TECHNICAL BULLETIN

FAM-A-0091-A

Production Discontinuation of the FX3G Series

■ FX5S

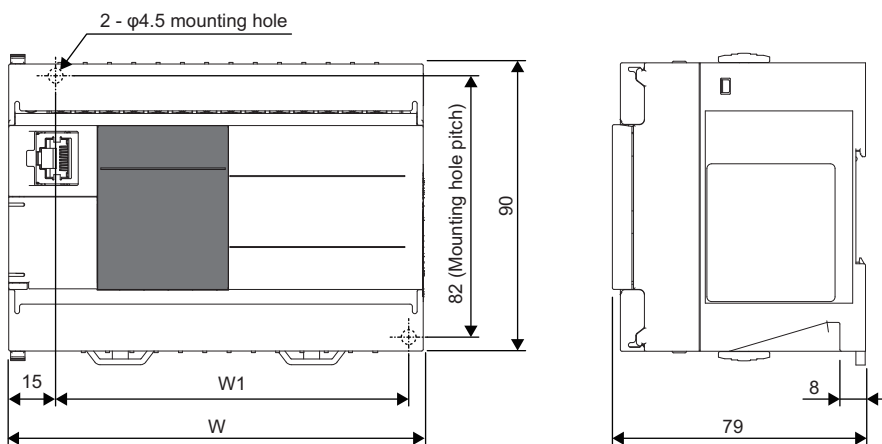
Model	W	W1
FX5S-30M□	100 (+10)	81 (-1)
FX5S-40M□	130 (±0)	111 (-11)
FX5S-60M□	175 (±0)	156 (-11)

Dimensional differences from the FX3G are shown in parentheses ().

■ FX5UJ

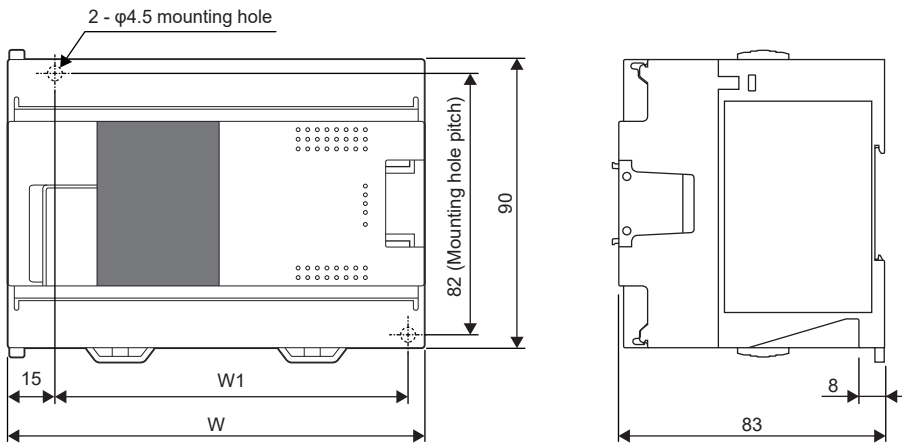
Model	W	W1
FX5UJ-24M□	95 (+5)	76 (-6)
FX5UJ-40M□	130 (± 0)	111 (-11)
FX5UJ-60M□	175 (± 0)	156 (-11)

Dimensional differences from the FX3G are shown in parentheses ().

■ FX5UC

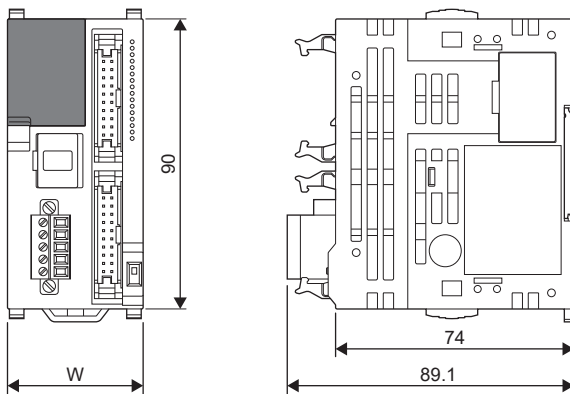
Model	W
FX5UC-32MT/D□□	42.1 (+8.1)

Dimensional differences from the FX3GC are shown in parentheses ().
